DEVELOPMENT AND INFRASTRUCTURE SERVICES COMMITTEE MEETING

12 June 2024

Report No.	Description	Page No.
	Development and Infrastructure Services Committee	
DIS397	Whalers Beach Public Infrastructure Coastal Hazard Risk Management Plan	1
DIS397	Schedule of Submissions - Whalers Beach	105
DIS398	Planning Report to Support a Planning Application for Proposed Mobile Telecommunication Facility	127
DIS398	Setback Variation Justification – Telecommunication Facility	169
DIS398	Summary of Submissions - Proposed Telecommunications Infrastructure	172
DIS400	Park Inspection Form	177
DIS400	Developed Managed Space – Parks and Garden Policy	183

**Whalers Beach Public Infrastructure
Coastal Hazard Risk Management & Adaptation
Plan**

Figure 2.8 Location of the DoT Waverider Buoy

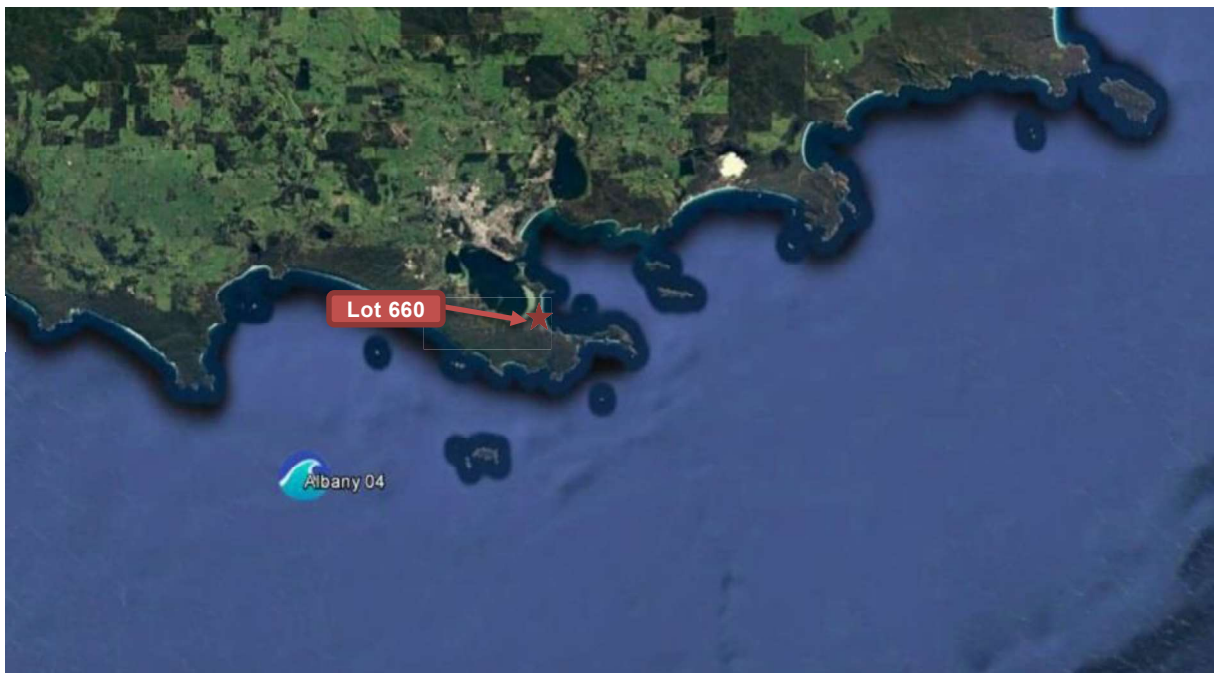
Summary of submissions	Officer Comment
<ul style="list-style-type: none"> • Section 2.4.1. Note the use of Frenchman Bay in this section is correct, as it could apply to the entire bay. • Why is Lot 660 shown on Figure 2.8? • Figure 3.5 and 3.8 show Whalers Beach!! • Conclusions. <i>“This report presents the results of the coastal hazard assessment for the Frenchman Bay Shoreline”</i>. All 7km of it? <p><u>These are just a few examples of the errors in nomenclature in these and other reports of the Whalers Beach area. The errors are widespread.</u></p> <p>3. <u>CHRMAP MANAGED RETREAT DESIGN AND SLOPE GEOTECHNICAL PARAMETERS</u></p> <p>There have been two CHRMAP reports completed recently by M P Rogers - for the recent Seashells projects and the City of Albany (December 2023). These reports basically describe: (i) current and future coastal conditions at Whalers Beach; (ii) the impact these conditions have on the beach and land above the beach; and (ii) the implications for future planning of development and public beach facilities on and above Whalers Beach. These are detailed, complicated and comprehensive reports, which are probably difficult for the layperson to understand completely. In my simple terms, this report describes the interaction between the predicted future coastal processes along the eastern section of Whalers Beach and whether/how these processes will impact on future development planning for Lots 1 and 2, FBR and public recreational infrastructure on Whalers Beach.</p>

Figure 3.4 Storm Conditions for use in Storm Erosion Modelling (as determined for the area immediately offshore from the Resort site)

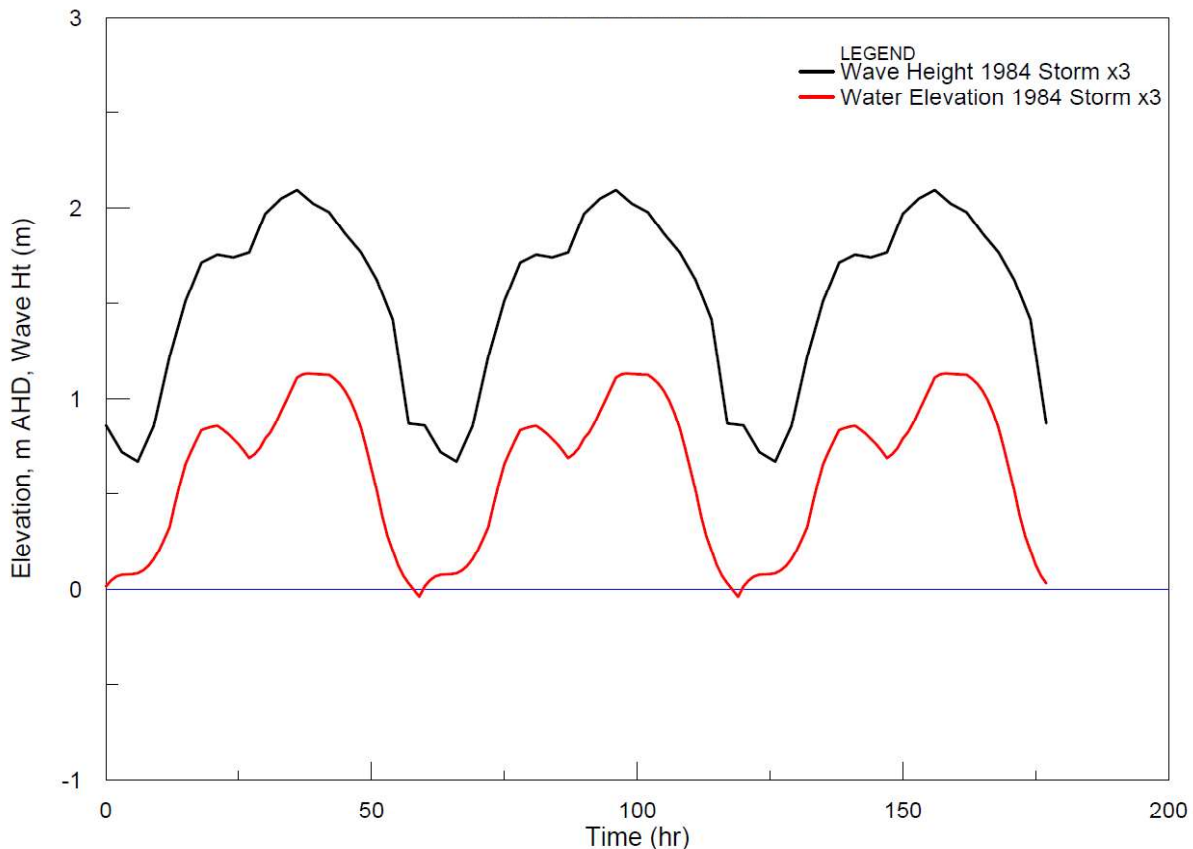
Summary of submissions	Officer Comment
<p>ii. Similarly, the document refers to work by Larson and Kraus on storm modelling and beach change (Figure 3.4, p.20). Yet, Robert S. Young et al have serious reservations about Kraus' studies and since, most (if not all) of Kraus' work refers to shorelines dissimilar to the fine sand shorelines found facing King George Sound, their assessments appear to be, at best, of little value in this plan.</p> <p>"All of this uncertainty makes GENESIS, at best, a qualitative, not quantitative model, and at worst a model that, after a certain amount of assuming and adjusting input parameters, produces a result that the coastal "expert" employing its services expected a way of backing up one's judgment with what appear to be real numbers." (Robert S. Young, et al.)</p> <p>3. Failure to Use Local Research</p> <p>It is unfortunate that this CHRMAP fails to reference available modelling provided to CoA (and available to the public) by geologist, (the late) Dr John Myers. Myers (a highly respected geologist with international credentials) conducted careful analysis of the shorelines near Frenchman Bay with relevant reference to research available prior to 2018. His modelling, including the scaled 3D model of Goode Beach dunes, should be considered in conjunction with this CHRMAP. His discussion of work prepared by A P Rogers for Cherry Martin (referenced in this draft CHRMAP) should be read in reference to this plan.</p> <p>Conclusion</p> <p>I commend the CoA for commissioning a CHRMAP for the various shorelines for which CoA has some responsibility. I acknowledge the difficulty of preparing such a draft plan of action, however even in the short time available</p>
